# **Intel® Mobile Celeron™ Processor Specification Update**

Release Date: March 1999

Order Number: 244444-002

**Figure 1. An Example of Microcontroller Driven Thermal Management**

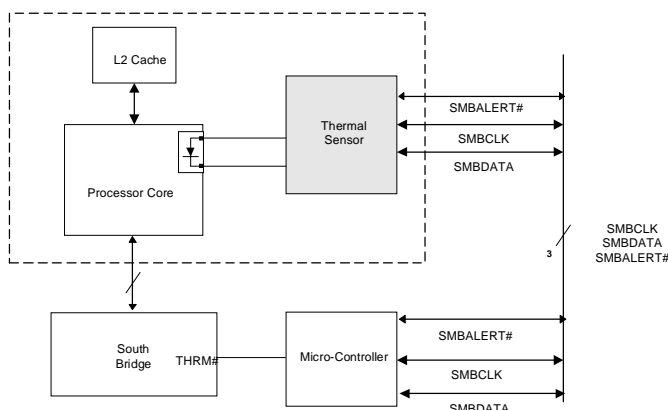
## ***H29. Thermal Sensor May Assert SMBALERT# Incorrectly***

**PROBLEM:** The Intel Celeron Processor Mobile Module has a thermal sensor that monitors the processor core's temperature. Please note that desktop systems could have a similar thermal device. The thermal sensor asserts SMBALERT# if the processor temperature exceeds the temperature limits set in the Alarm Threshold Registers ( $T_{HIGH}$ ,  $T_{LOW}$ ). It also sets the corresponding Status Register bits to identify the cause of the interrupt. Figure 1 gives one example of the how the SMBALERT# signal could be used in a system.

Under the conditions described below, the thermal sensor incorrectly generates the SMBALERT# interrupt. *All* of the following conditions must be met to trigger a false interrupt:

**WORKAROUND:** Three different (mutually exclusive) workarounds are possible:

1. Before servicing an interrupt from the thermal sensor, read and compare the processor thermal reading with the threshold limits ( $T_{HIGH}$  or  $T_{LOW}$ ). Figures 2 and 3 provide basic flowcharts for the implementation of this workaround in an interrupt driven system.
2. If the firmware implemented polls the Status Register only, then before taking any action, re-read the temperature register and do a comparison with the alarm threshold limits ( $T_{HIGH}$  or  $T_{LOW}$ ) to determine if the value is actually still within the temperature window.
3. Use a temperature polling scheme to monitor the processor temperature.
